**RE: Petition No. 1476 - AT&T Interrogatory Responses**

**NEW CINGULAR WIRELESS PCS, LLC (AT&T) ) PETITION NO. 1476  
PETITION FOR A DECLARATORY RULING )  
THAT NO CERTIFICATE OF ENVIRONMENTAL )  
COMPATIBILITY AND PUBLIC NEED IS )  
REQUIRED TO MODIFY AN EXISTING )  
WIRELESS TELECOMMUNICATIONS FACILITY )  
ON PROPERTY LOCATED AT 2627 DAY HILL )  
ROAD, BLOOMFIELD, CONNECTICUT. ) February 22, 2022**

**RESPONSES OF NEW CINGULAR WIRELESS PCS, LLC  
d/b/a AT&T TO CONNECTICUT SITING COUNCIL INTERROGATORIES  
DATED JANUARY 28, 2022**

**PARCEL PLAN**  
 22x34 SCALE: 1"=100'  
 11x17 SCALE: 1"=200'

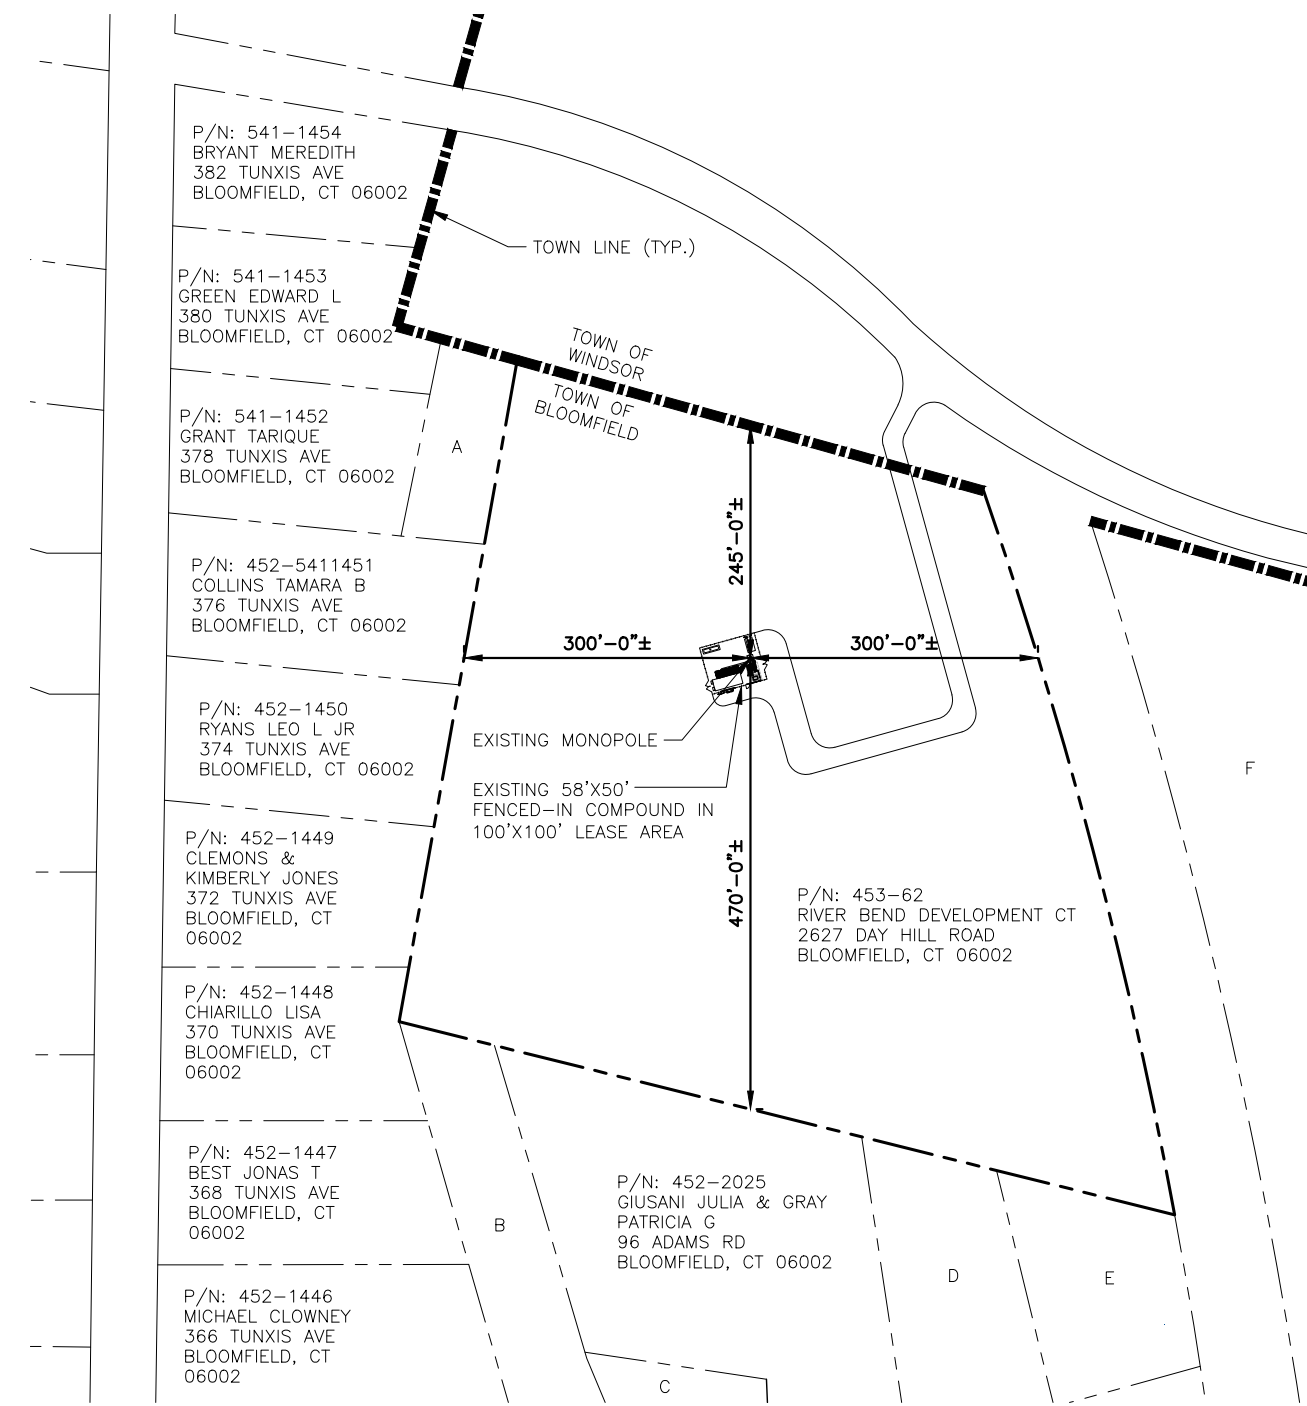
**Q3. Petition Attachment 3 - Drawing C-1, General Note No. 9 references site development for erosion and sediment control in accordance with Vermont Department of Environmental Conservation. Clarify the information and provide a revised Drawing C-1.**

*A3. Please see revised drawings removing the notes on Drawing C-1.*
